UNITED STATES PATENT AND TRADEMARK OFFICE

APPLICATION NO.	FILING DATE	FIRST NAMED INVENTOR	ATTORNEY DOCKET NO.	CONFIRMATION NO.
10/732,935	12/10/2003	Brent L. Bristol	H0005435--1180	7284
7590 09/01/2005 HONEYWELL INTERNATIONAL, INC. Law Dept. AB2 P.O. Box 2245 Morristown, NJ 07962-9806			EXAMINER EDGAR, RICHARD A	
			ART UNIT 3745	PAPER NUMBER

Office Action Summary

Drawings

FIG. 4

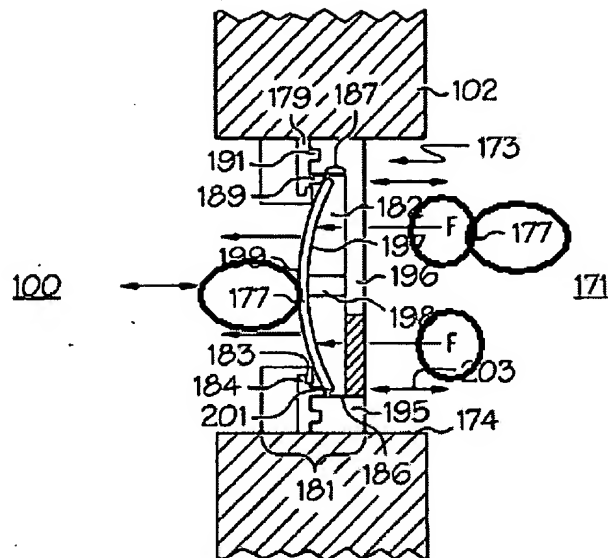
The drawings are objected to as failing to comply with 37 CFR 1.84(p)(4) because reference character "177" has been used to designate different elements (see Fig. 4 annotated on the following page).

The drawings are objected to as failing to comply with 37 CFR 1.84(p)(5) because they include the following reference character(s) not mentioned in the description: "F" and "301" (see Figs. 4 and 5 annotated on the following page).

Corrected drawing sheets in compliance with 37 CFR 1.121(d), or amendment to the specification to add the reference character(s) in the description in compliance with 37 CFR 1.121(b) are required in reply to the Office action to avoid abandonment of the application. Any amended replacement drawing sheet should include all of the figures appearing on the immediate prior version of the sheet, even if only one figure is being amended. Each drawing sheet submitted after the filing date of an application must be labeled in the top margin as either "Replacement Sheet" or "New Sheet" pursuant to 37 CFR 1.121(d). If the changes are not accepted by the examiner, the applicant will be notified and informed of any required corrective action in the next Office action. The objection to the drawings will not be held in abeyance.
